Region 10 Enforcement and Compliance Assurance Division
1200 6th Avenue
Seattle, WA 98101
INSPECTION REPORT

Inspection Date:	02/23/2021	
Time:	Entry: 1:45 p.m.	Exit: 4:30 p.m.
Media:	Water	
Regulatory Program:	CWA NPDES/Construction Stormwater	
Operator Name(s):	Toll Brothers, Inc. – (Notice of Intent IDR100113)	
Operator Addresses:	3103 W. Sheryl Drive Suite 100	
Operator City, State, Zip Code:	Meridian, Idaho 83642	
Site Name:	The Oaks North	
Site Physical Location:	5380 W. McMillian Road	
	Latitude/Longitude	43.6505°N, 116.4684°W
City, State, Zip Code:	Meridian, Idaho 83646	
Site Contact(s):	Brett Calhoun, Stormwater Compliance Inspector Phone: (408) 603-4889 Email: jcalhoun@tollbrothers.com	Toll Brothers, Inc.
County:	Ada County, Idaho	
Site Identifier:	The Oaks North	
Estimated Site Area to be Disturbed:	228.25 acres	
Site Receiving Water(s)	South Slough Canal and West Tap Sublateral	
Site Receiving Water(s) Description:	Irrigation canals	
NPDES Permit:	2017 EPA Construction General Permit (CGP)	
EPA Site Tracking Numbers:	IDR1000113

Photograph 1. View, facing south, of an unprotected stockpile on North Sunfield Road. Note the vehicle track-out in the foreground.

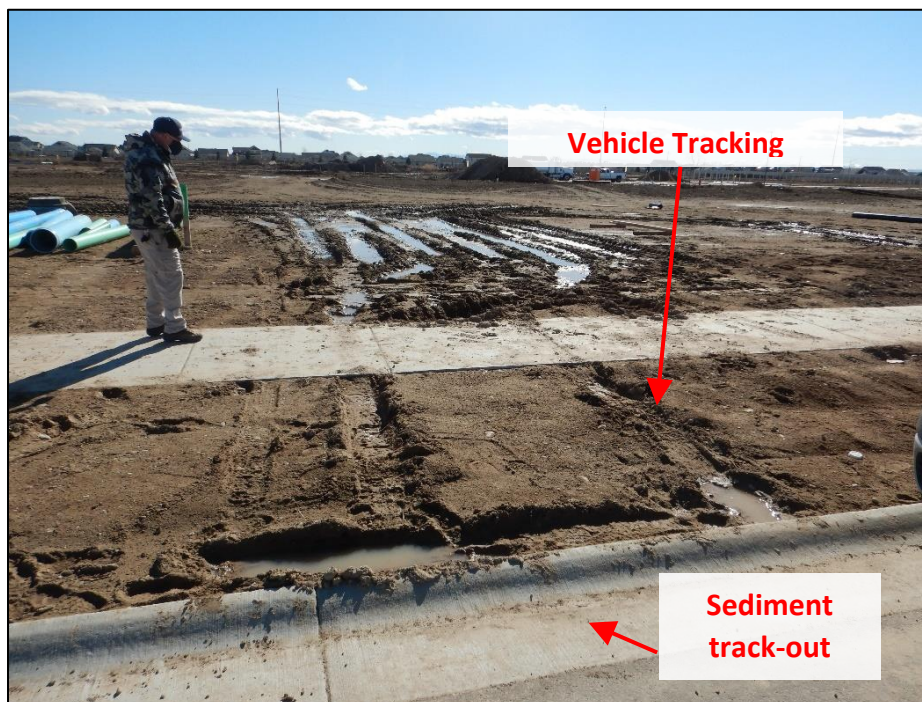
We observed an unstabilized soil stockpile on North Sunfield Road adjacent to the Site access point on West Millano Drive in Phase 4. The stockpile was positioned adjacent to an unstabilized Site entrance in Phase 4 and appeared to be contributing to sediment track-out occurring in the area. We observed that the stockpile did not have any sediment barriers along the downgradient perimeter area on the roadway (refer to [Attachment A, Photograph 1](#)).

Photograph 3. View, facing west, of unrestricted vehicle access along the northern perimeter of Phase 4. Note no stabilization techniques had been implemented to prevent sediment track-out.

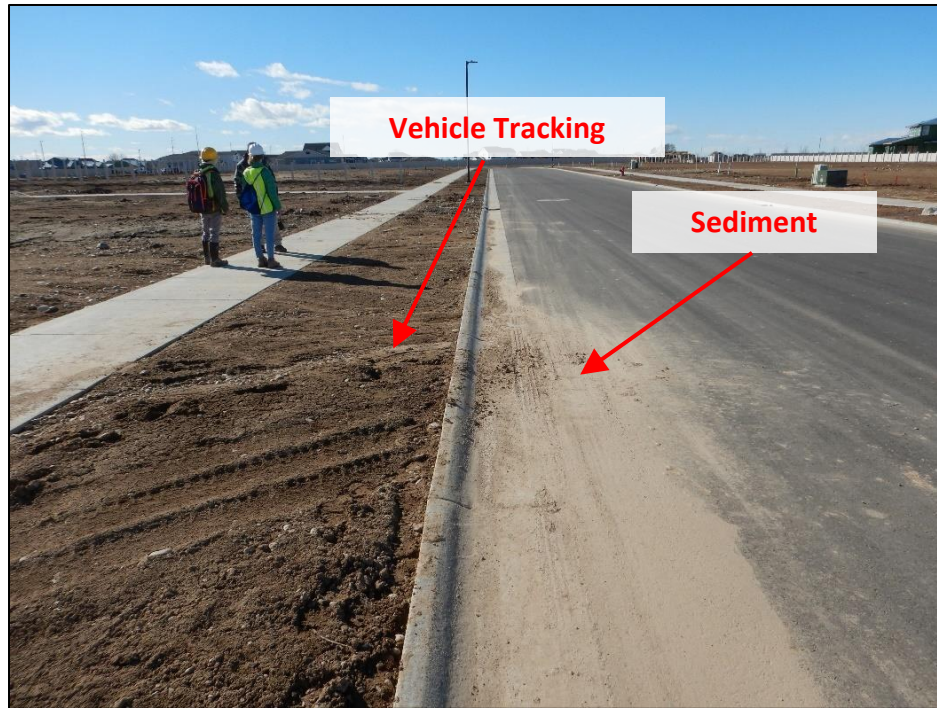
We observed that construction vehicle access had not been restricted to properly designated exit points in Phase 4. We observed three locations along the northern perimeter of Phase 4 on West Avilla Drive and one area on North Sunfield Road where the Site had been accessed by vehicles or construction equipment at non-designated exits. In all instances, stabilization techniques had not been installed at points where vehicle traffic entered on to paved roadways (refer to Attachment A, Photographs 1 through 6).

Photograph 8. View, facing east, of a 500-gallon fuel tank at the eastern end of West Avilla Drive that was not covered or in secondary containment. Petroleum staining was visible on the outside of the tank.

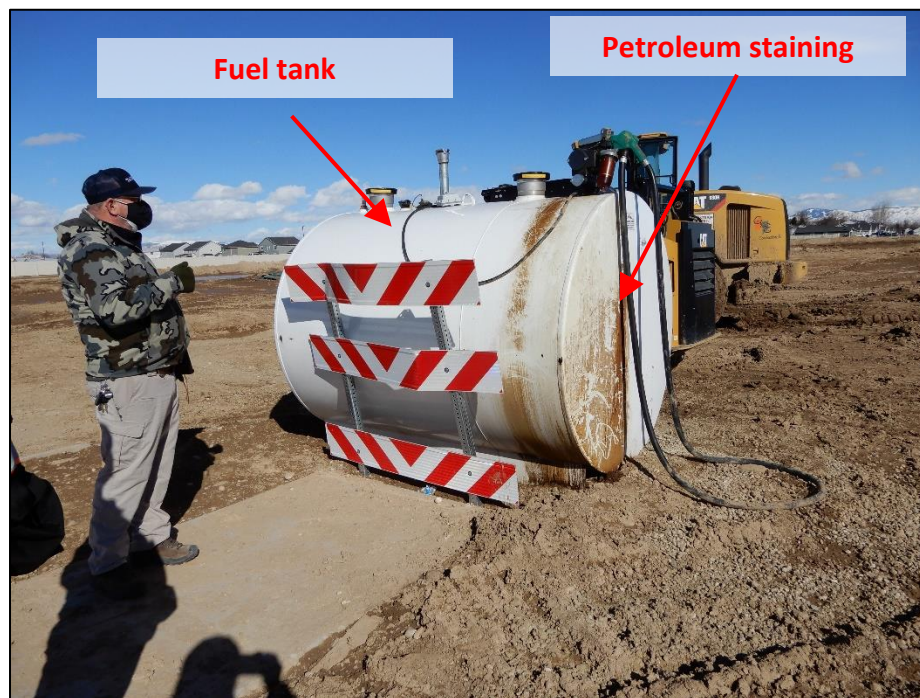
We observed a 500-gallon fuel tank adjacent to the access point on the eastern end of West Avilla Drive in Phase 4 that was not under a cover and did not have secondary containment. No spill kit was observed in the area to respond to any spills or leaks that occurred. Additionally, the fuel tank was observed to have petroleum residue on the outside of the tank (refer to Attachment A, Photograph 8).

Photograph 9. View, facing east, of the southern perimeter in Phase 7. Note the absence of perimeter controls adjacent to West McMillian Road.

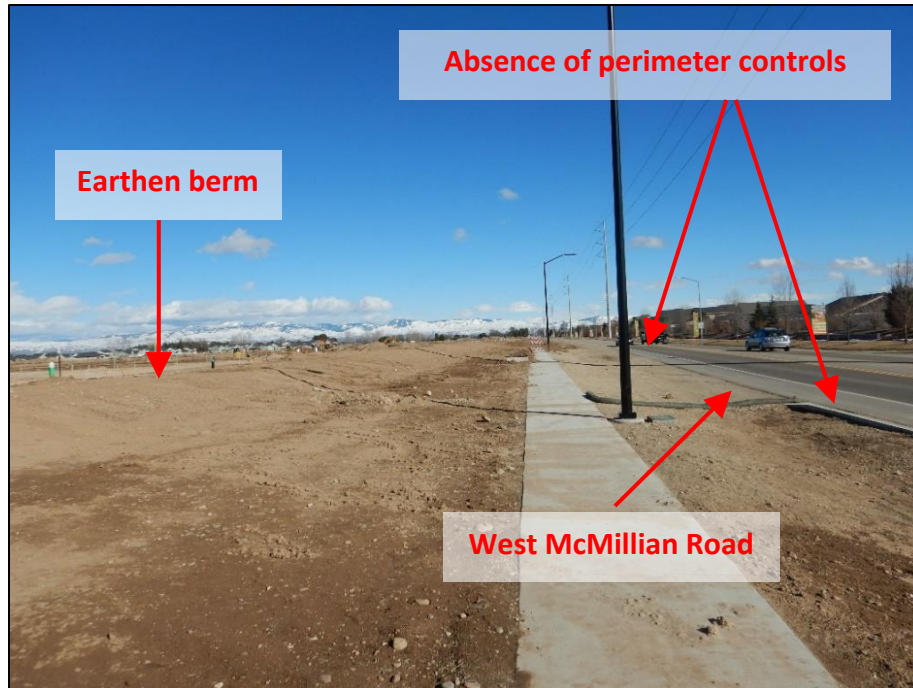
We observed a lack of effective sediment controls along the southern perimeter of the Site adjacent to West McMillian Road. We observed that the disturbed area along Phases 5 and 7 were adjacent to West McMillian Road and received runoff from the Site. No perimeter controls had been installed to prevent sediment from leaving the Site (refer to Attachment A, Photograph 9).

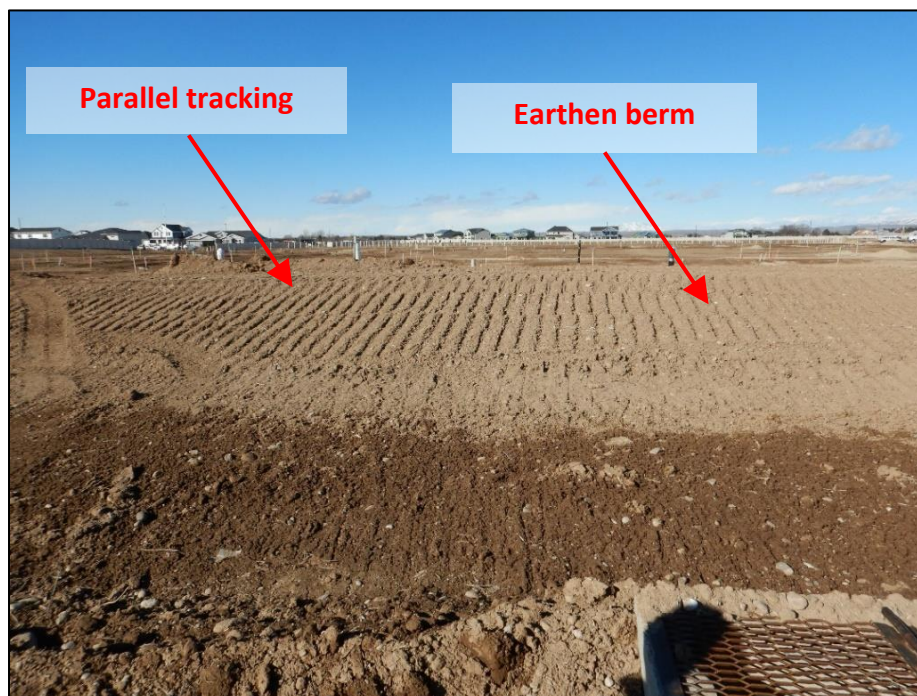
Additionally, along the Site’s southern perimeter, an earthen berm had been constructed as a part of the permanent landscaping plan. We observed that the berm had been compacted and tracked. However, the tracking was parallel to the slope instead of perpendicular, creating the potential for increased erosion (refer to Attachment A, Photograph 10).

Photograph 11. View, facing south, of the southern perimeter of the Oaks North Subdivision Phase 5. An inlet to the Meridian MS4 was observed to not have inlet protection and had the potential to receive runoff from exposed soil on the Site.

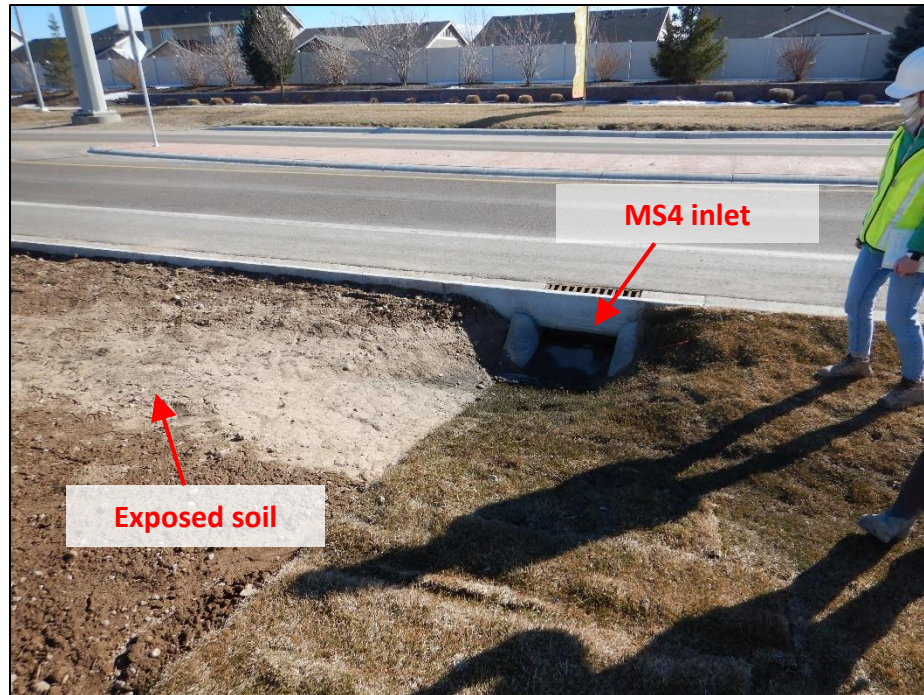
In the southwestern corner of Phase 5 we observed an unstabilized earthen swale that led to an unprotected MS4 inlet (refer to Attachment A, Photographs 11 and 12). During the post-inspection document review it was noted that the unprotected inlet was not identified as a discharge point on the Site’s SWPPP map (refer to Attachment D).

Photograph 14. View, facing northeast, of a drainage/dewatering ditch observed in Phase 6. Rock check dams had been installed along the length of the ditch.

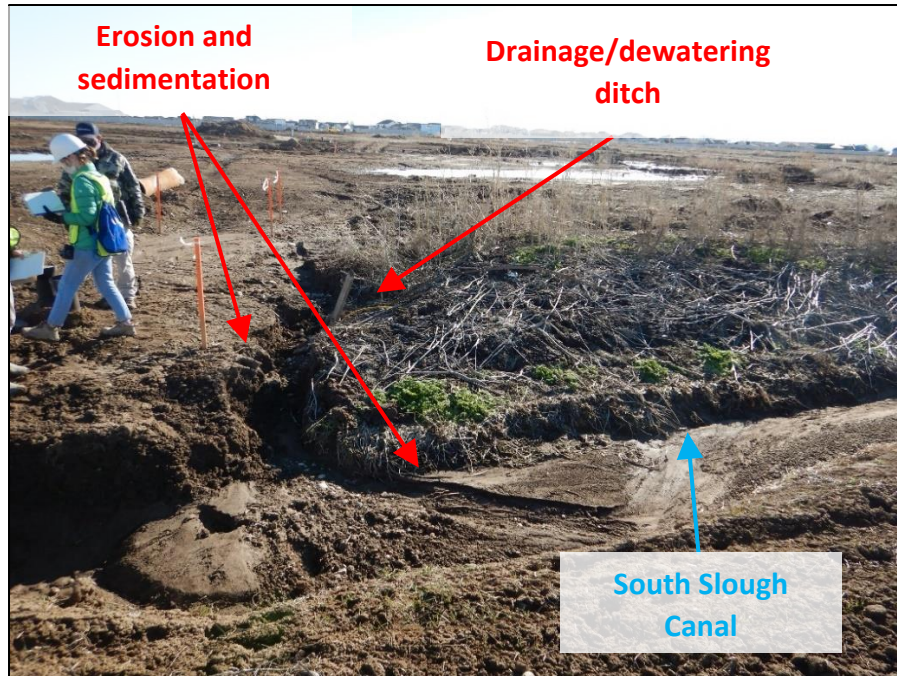
We observed a drainage/dewatering ditch along the western perimeter of Phase 6 that had been installed within the Site. At the time of the inspection, the ditch did not have flow in it. We observed that rock check dams had been installed along the length of the ditch. Mr. Calhoun stated that these had been installed to help reduce erosion and sediment discharges. The ditch met with the South Slough Canal at the northern perimeter of Phase 6. At the confluence of the drainage ditch and South Slough Canal, we observed an erosional cut and sediment deposited within South Slough Canal. At the time of the inspection, there was no water flowing in South Slough Canal (refer to Attachment A, Photographs 14 through 16).

Exhibit 2. Image of the Site map provided on Site of the Oaks North. Note that the Site map does not identify the elements required by Part 7.2.4.b through 7.2.4.j of the Permit.

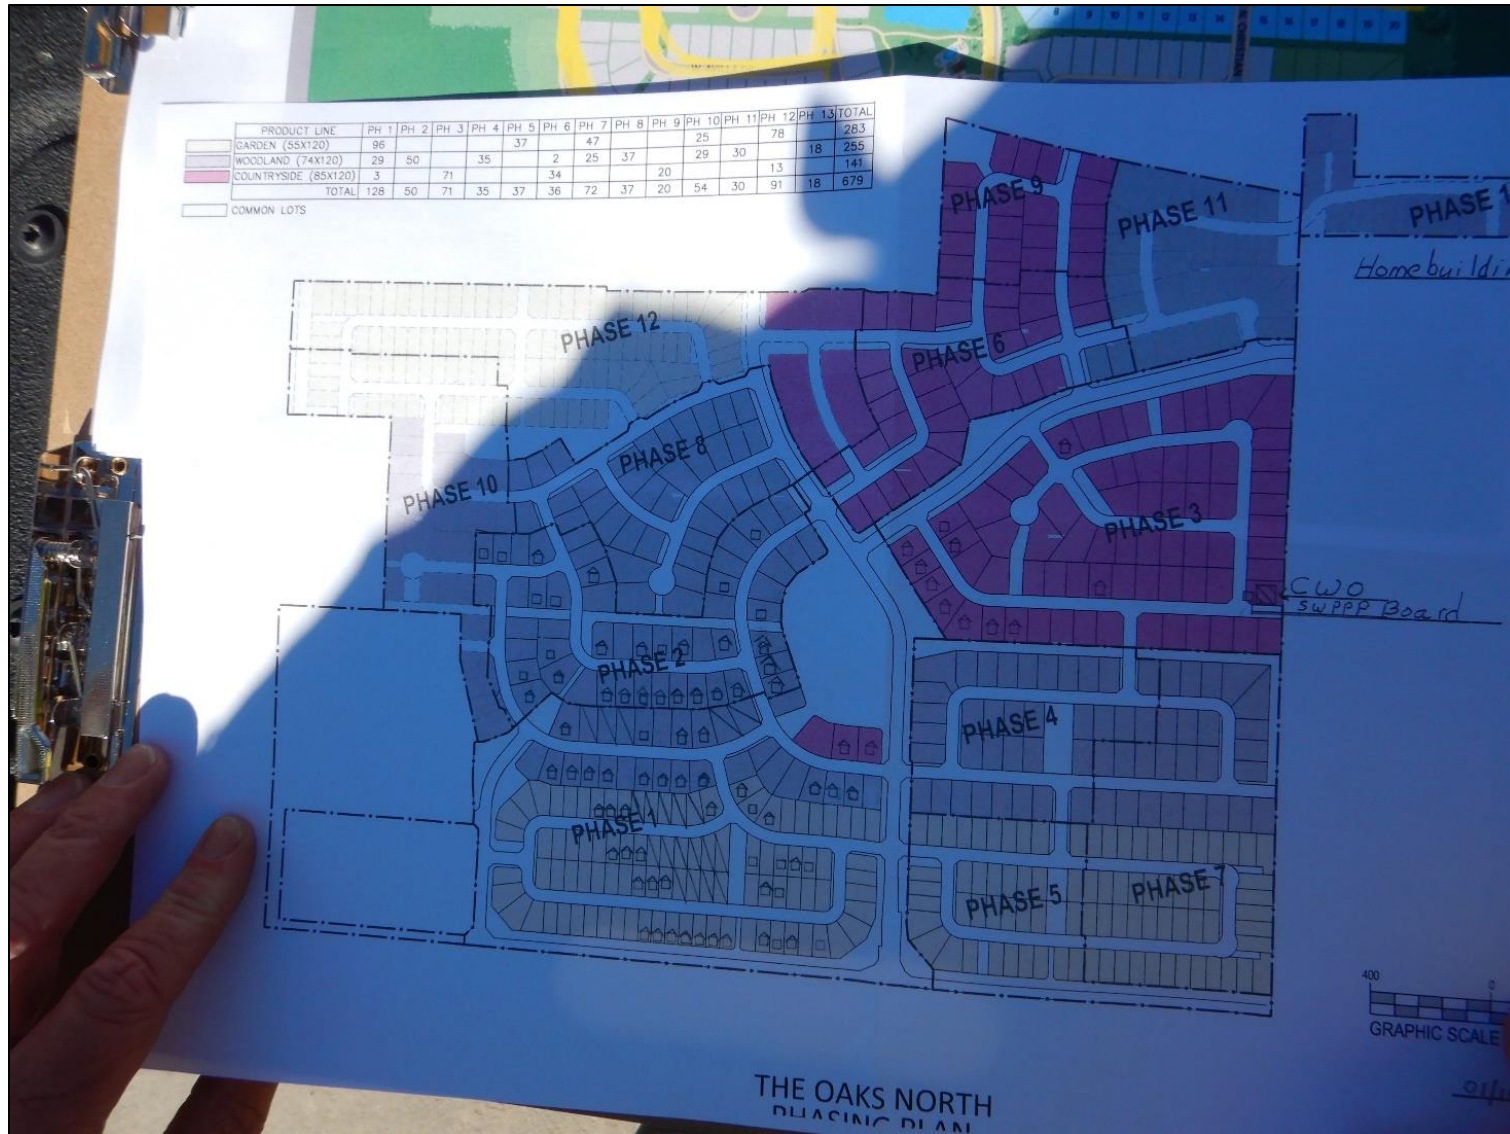
During the initial onsite records review, we observed that the SWPPP Site map and additional Site maps were not included in the SWPPP did not include all minimum information as required by Part 7.2.4 of the Permit. Specifically, the Site map did not identify the elements required by Part 7.2.4.b through 7.2.4.j of the Permit. Mr. Calhoun stated that additional Site maps existed that depicted the required elements, but at the time of the inspection, they could not be located (refer to Attachment B, Exhibits 2 and 3).
